Louisiana Energy Services, LLC
National Enrichment Facility
NRC Docket No. 70-3103

Subject: Response to NRC Review of the 10 CFR 70.72 Summary of Changes for Louisiana Energy Services

- CC-EG-2006-0033**, *Security System UPS and Diesel Generator*
- CC-EG-2007-0061**, *Removal of Diesel Backup Power for Product Pumps and Blending System Trace Heating in SBM-1001*
- CC-EG-2007-0056**, *Process Service Corridor – Addition of Security Access Door*
- CC-EG-2007-0085**, *Modification to Facility Water Feed – From Eunice, NM*
- CC-EG-2006-0073**, *HVAC Design Changes for Centrifuge Assembly Building*
- CC-EG-2007-0226**, *QA Level 2 Definition and QA Level 1 Clarification*
- CC-EG-2007-0189**, *Changes to IROFS Temperature Sensor*
- CC-EG-2007-0232**, *Review of NTS Calc M-0006-02 Water Balance (NTS-LES-0549)*

SITE PLAN

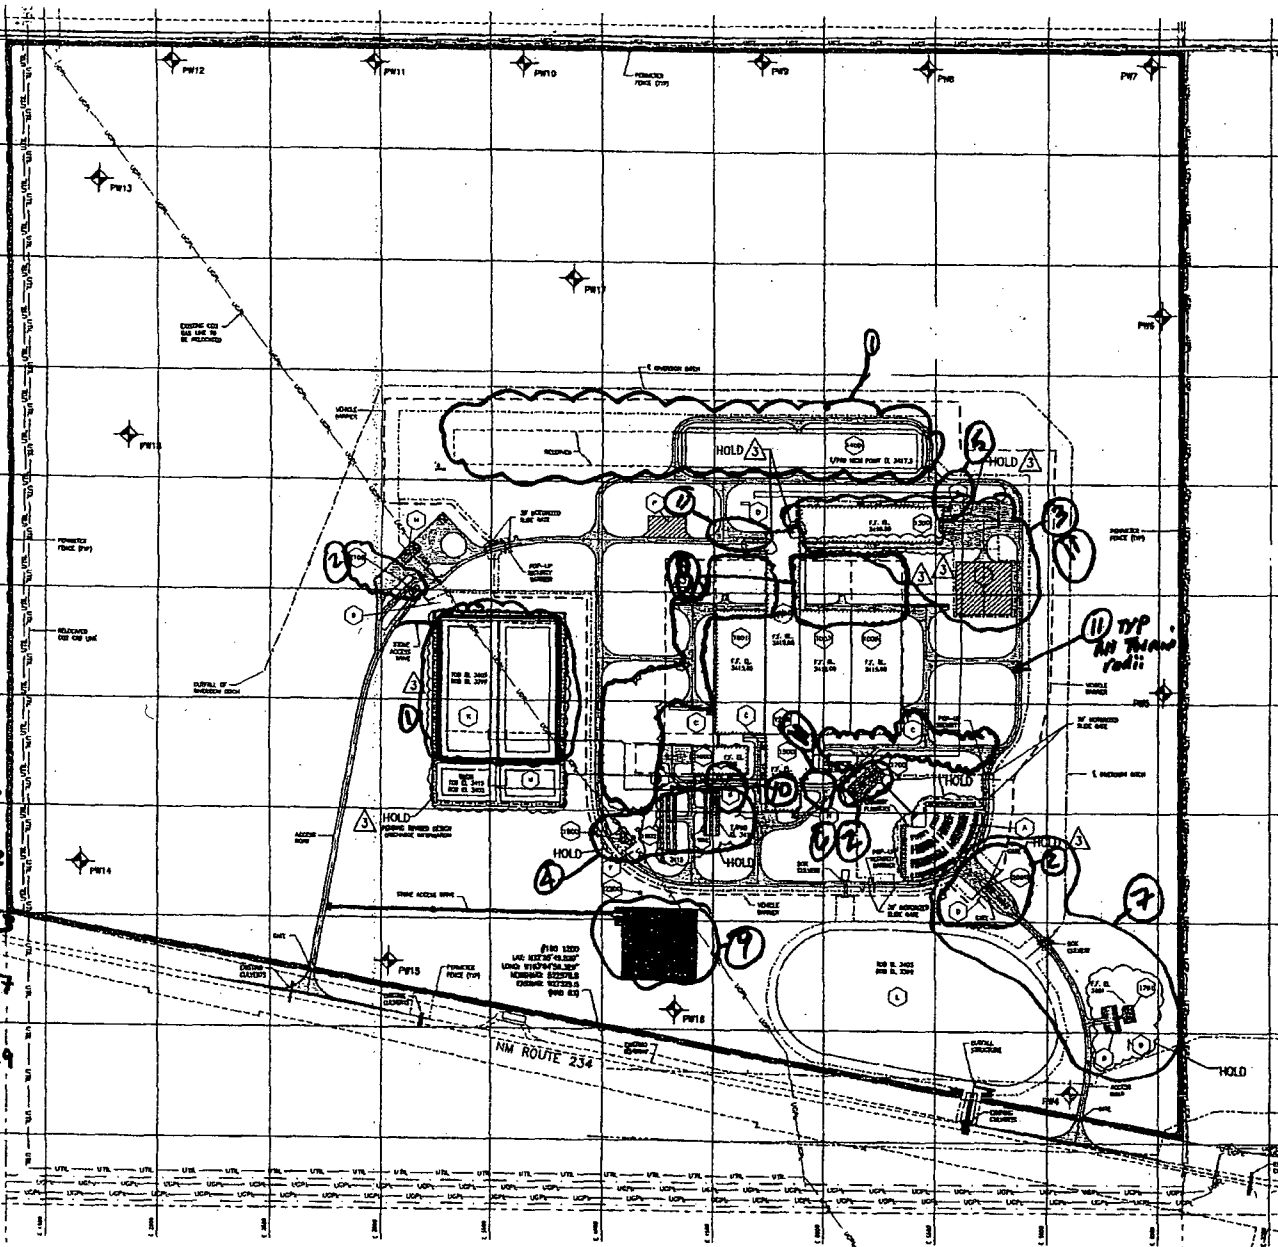
Change Topic	Description of Change	Emergency Plan (EP)	Environmental Report (ER)	Integrated Safety Analysis Summary (ISAS)	Safety Analysis Report (SAR)	Fundamental Nuclear Material Control Plan (FNMCP)
Site Plan Revision	The site plan has changed, therefore, various sketches provided in the LB documents require revision to reflect the current site plan. This CC covers the changes reflected in the following DCCs, which are cross-referenced to their corresponding CCs (see table below).	Figures: 1.2-1; 1.3-1	Figures: 1.2-4; 2.1-2; 2.1-4; 3.3-12; 3.4-1; 3.6-11; 3.9-2; 3.12-1; 4.4-1; 4.9-1; 4.12-2; 4.12-3; 4.12-4; 6.1-1; 6.1-2	Figures: 3.2-2; 3.2-3; 3.3-1	Figures: 1.1-3; 1.1-4; 4.7-2; 7.5-1; 7.5-2	Figures: 5.1-1, 5.1-2, 5.1-3, D-3, D-4

1. Actual figure changes to be finalized by licensing basis document owners based on information presented in the attached NTS drawings 114489-0000-C-CVL-002-01 (Site Plan) and 114489-0000-C-CVL-001-01 (Topographic Survey).
2. Additional figures reflecting the site plan may also be impacted in the safeguarded licensing basis documents (e.g., Guard Force Training and Qualification Plan, Physical Security Plan, Standard Practice Procedures Plan for the Protection of Classified Matter). The impacts and revisions to those documents are to be addressed by Support Services.
3. For information, the NRC Environmental Impact Statement included the site layout in several figures (i.e., Figures 2-4, 2-6, 3-19, 4-1, 4-2, 6-1, C-1 and C-3). The EIS figures are not LES configuration documents and therefore are not subject to revision under this process.

SEPTIC PLAN &
UNDERGROUND UTILITIES PLAN
SHEET 1A

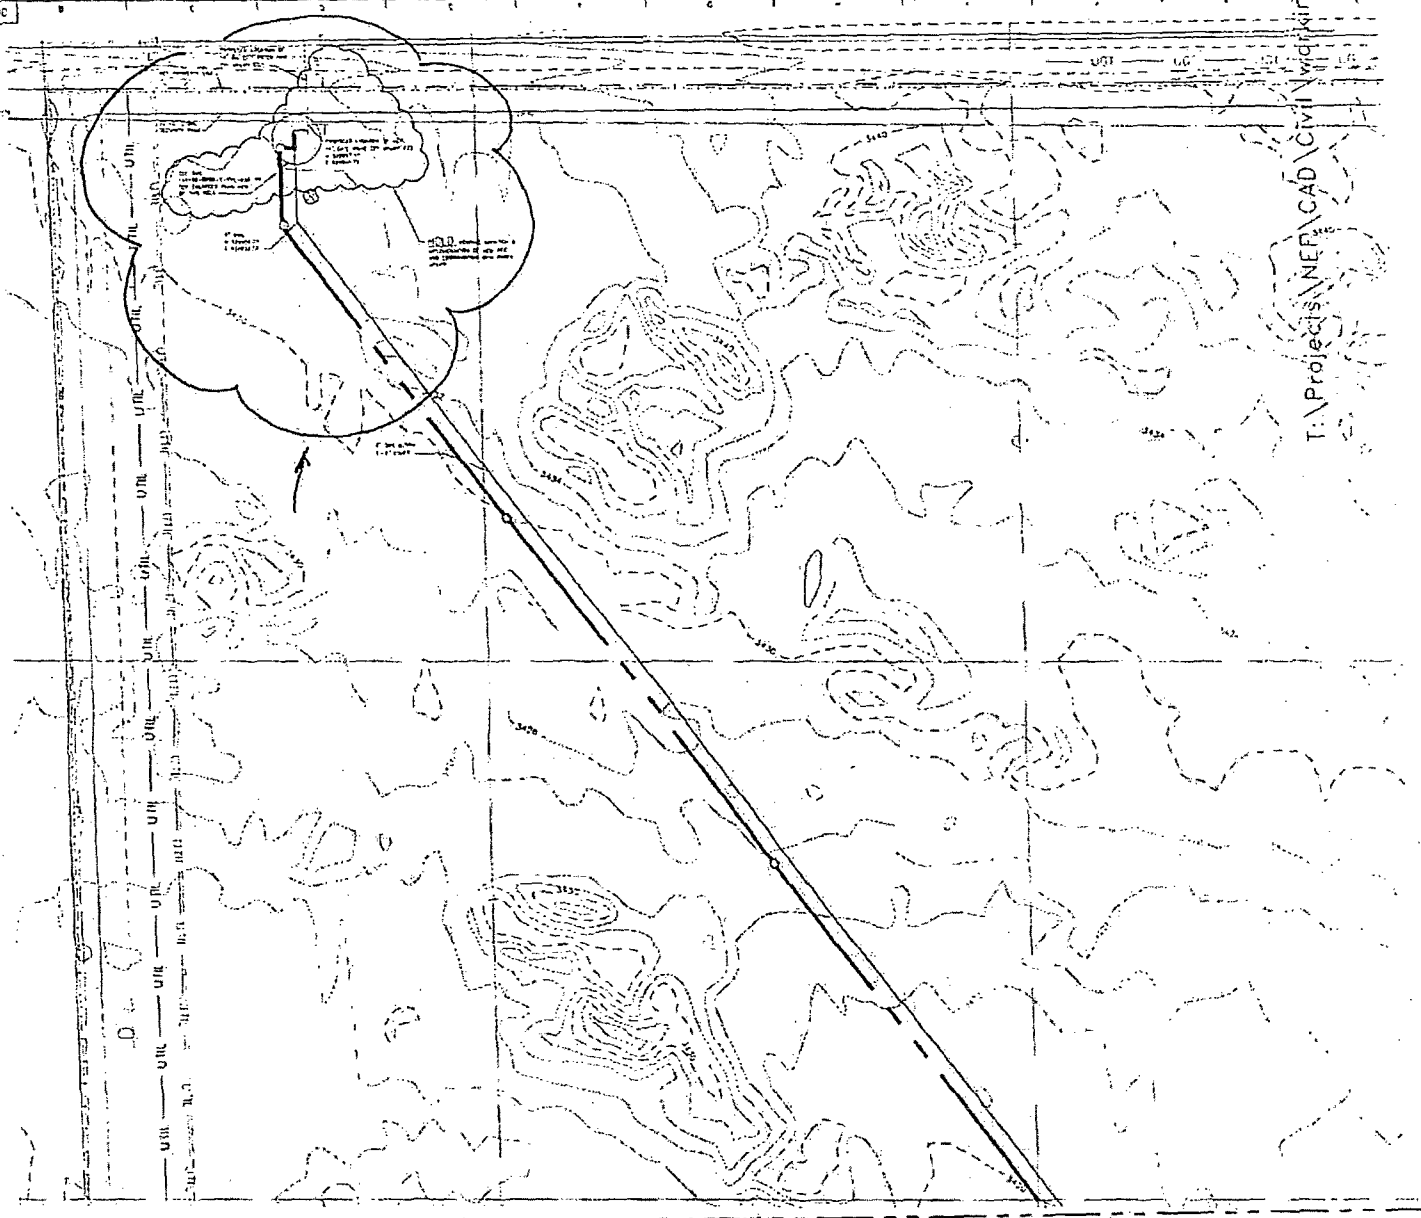
<table><tr> <td style="width:50%;">Emergency Plan – Sect 1.3.2, Page 1.3-2</td> <td style="width:50%;">Safety Evaluation Report – No Affected Pages</td> </tr><tr> <td>Env. Report – Sect 4.4.5 - Pages 4.4-,5,6</td> <td>Septic Plan, Etc, Sheet 1A, 114489-0000-C-CVL-006-01A-0</td> </tr></table>

SEPIC PLAN & UNDERGROUND UTILITIES PLAN
SHEET 3

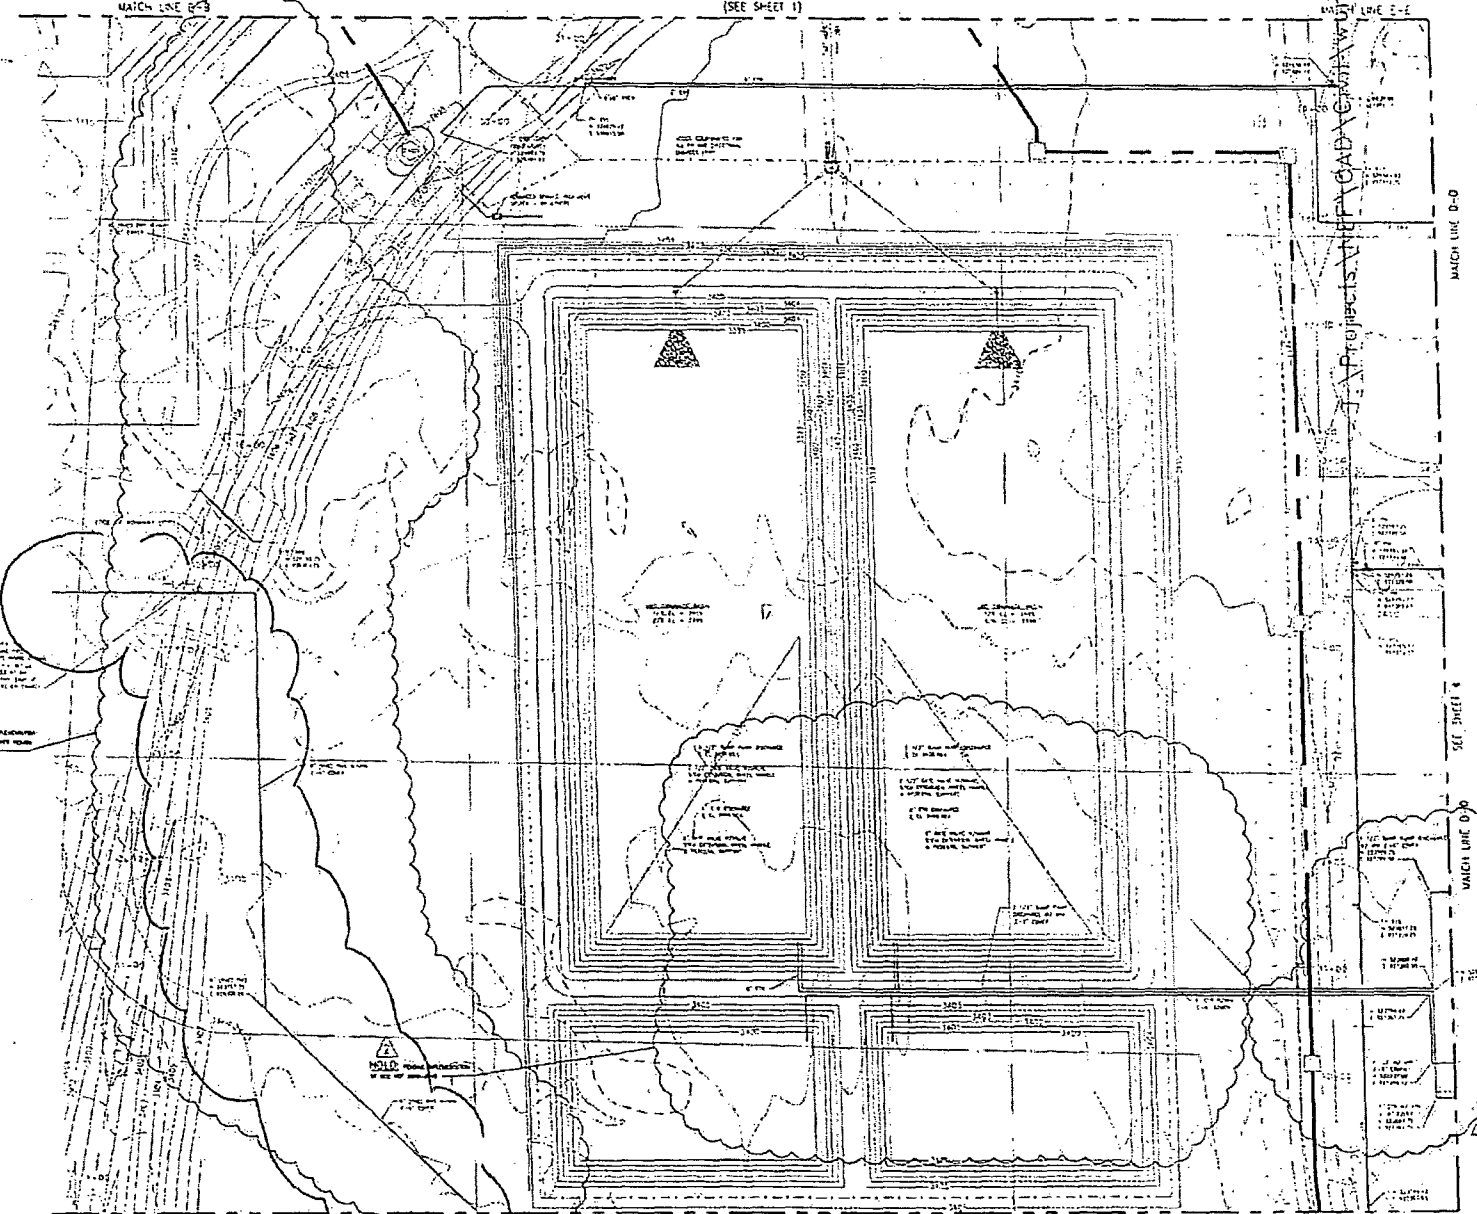
<table><tr> <td style="width:50%;">Emergency Plan – Sect 1.3.2, Page 1.3-2</td> <td style="width:50%;">Safety Evaluation Report – No Affected Pages</td> </tr><tr> <td>Env. Report – Sect 7.2.2.7 - Page 7.2-5</td> <td>Septic Plan, Etc, Sheet 3, 114489-0000-C-CVL-006-03-3</td> </tr></table>

CA LEVEL 3'
SEPTIC SECTIONS & DETAILS
SHEET 9

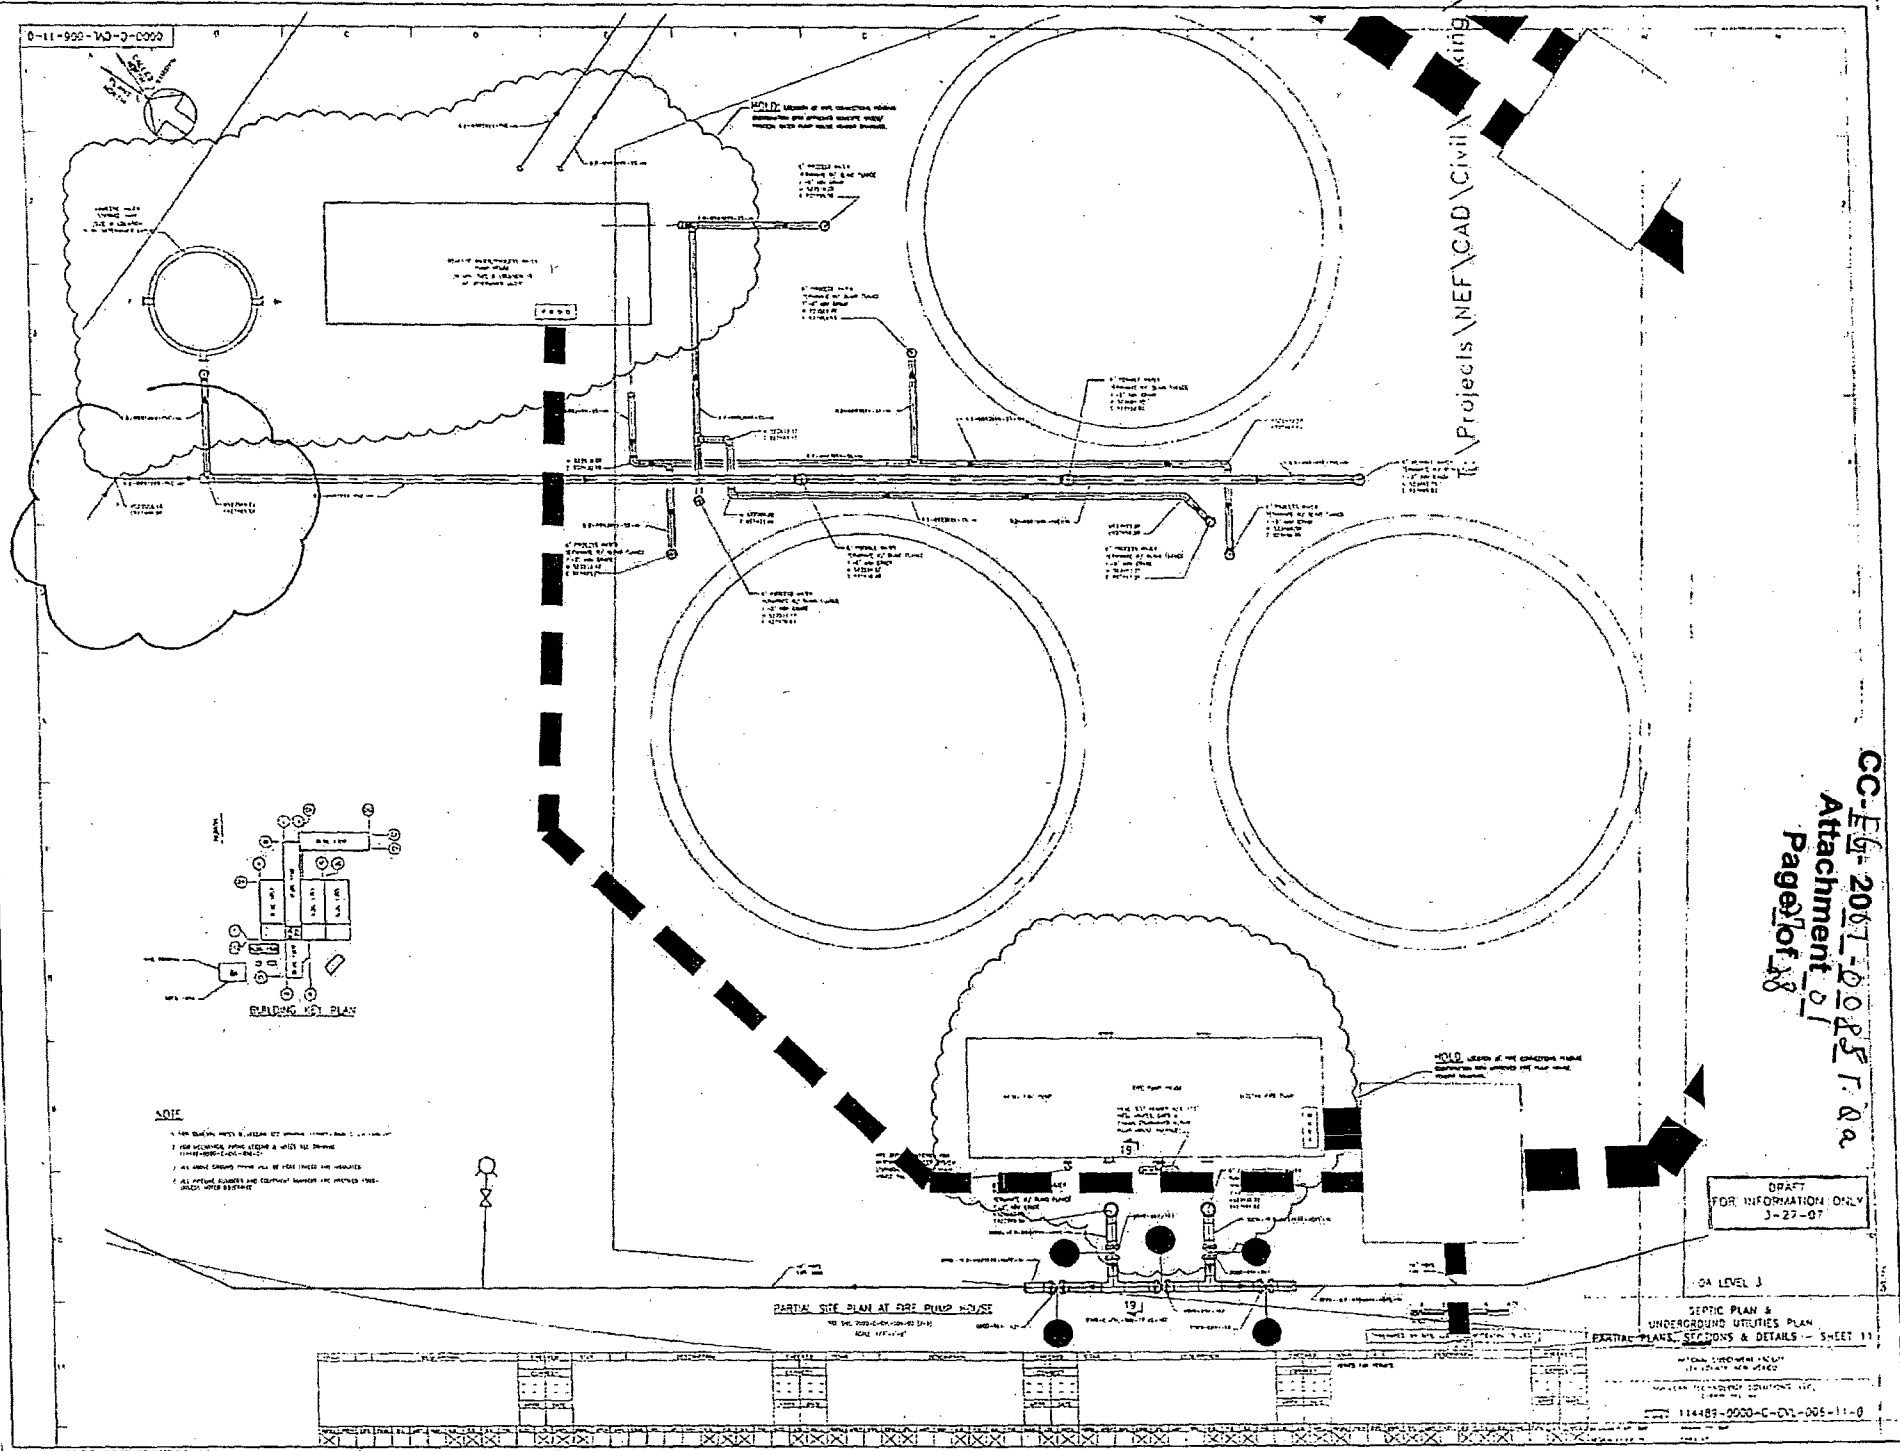
<table><tr> <td style="width:50%;">Emergency Plan – Sect 1.3.2, Page 1.3-2</td> <td style="width:50%;">Safety Evaluation Report – No Affected Pages</td> </tr><tr> <td>Env. Report – Sect 8.8 - Pages 8.8-1,2,3</td> <td>Septic Sects, Etc, Sheet 9, 114489-0000-C-CVL-006-09-1</td> </tr></table>

FIGURE 3.3-2
SEPARATIONS BUILDING MODULE
FIRST FLOOR

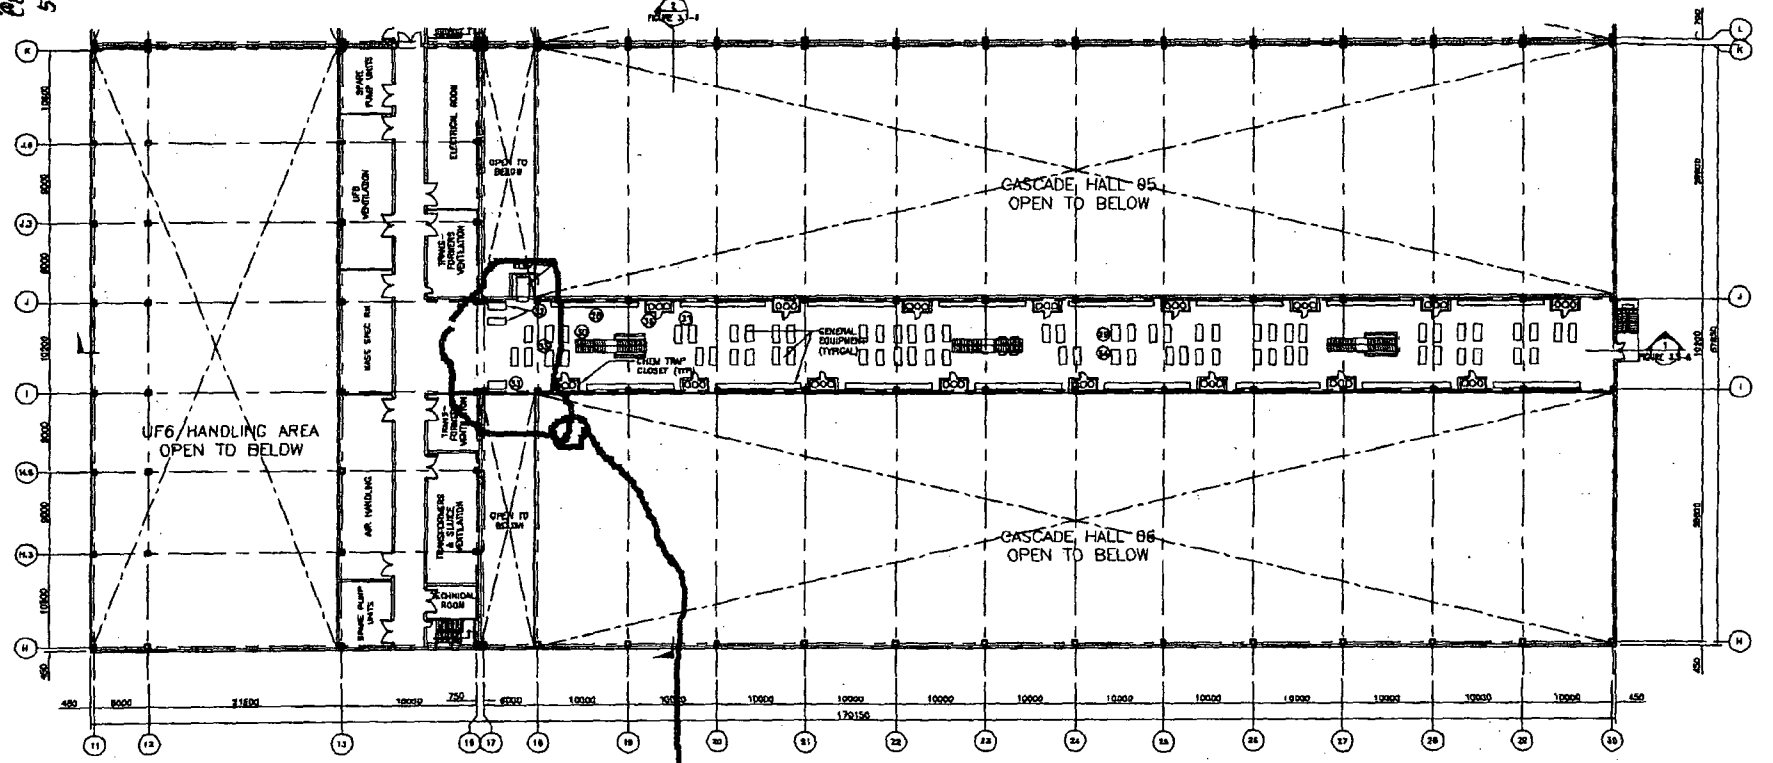
Reason for change:			Safety / Environment <input type="checkbox"/>
LES Security requires Personnel Access Control at the Process Service Corridor			Correction <input type="checkbox"/>
			Improvement <input checked="" type="checkbox"/>
Drawings/Documents Affected (including License Application and ISA Summary):			
<ol style="list-style-type: none"> 1. Architectural drawing 1001-C-ARC-002-01 2. Architectural drawing 1001-C-ARC-003-01 3. Architectural drawing 1001-C-ARC-004-01 4. SAR Figures: 1.1-3; 1.1-6; 1.1-7 5. ISA SUMMARY Figures: 3.3-2; 3.3-4; 3.3-6 			
Distribution: LES (D. SAVIN & S. Day), Urenco (A. Brown)			
Part 2 - Assessment (By Urenco Subject Matter Expert (SME), NTS SME, and AREVA ISA SME, as required. Also includes ETC review to ensure core technology is not compromised.)			
Add comments and return to individuals in Part 1 Distribution by: (Date) (+)			
No Comments, this change was made at the request of Security.
